SERVICE BULLETIN

MODEL NAME : Di620
MODEL CODE : 1155
NO. : 032
DATE : 990428
SUBJECT : COVER CHANGE

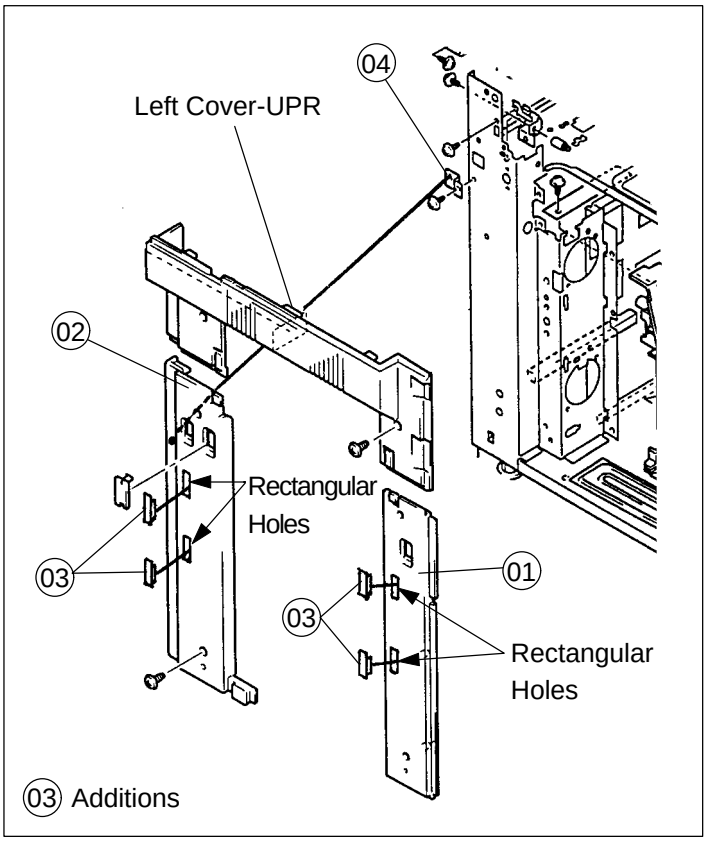
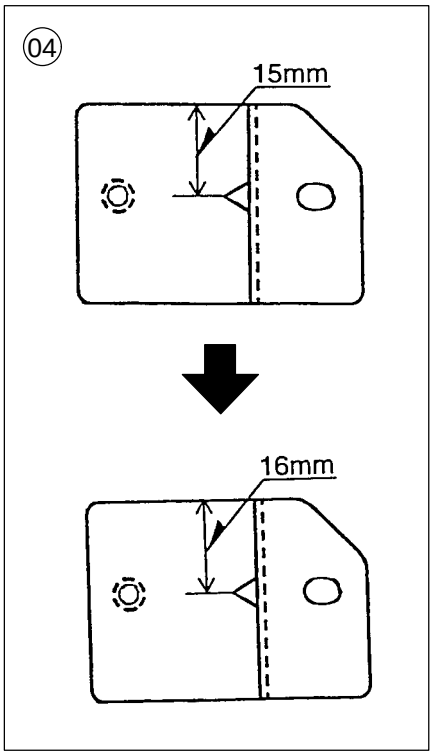
In order to make it possible to install the Finishers FN-102 and FN-502, the following changes have been implemented :

1. Two rectangular holes for the installation of the Finisher have been added to the Left Cover-Fnt (01) and Left Cover-Rr (02).
2. Due to the addition of the rectangular holes in the Left Cover-Fnt (01) and Left Cover-Rr (02), the new Covers (03) are removable.

In addition, because of differences in the way parts are installed, there is a possibility that the Left Cover-Rr (02) and Left Cover-Upr may interfere with each other. To prevent this, the shape of the Plate (04) has been changed to prevent interference.

NOTE: The new Covers (03) must be installed with the new Left Cover-Fnt (01) and Left Cover-Rr (02) as a set in premodification machines.
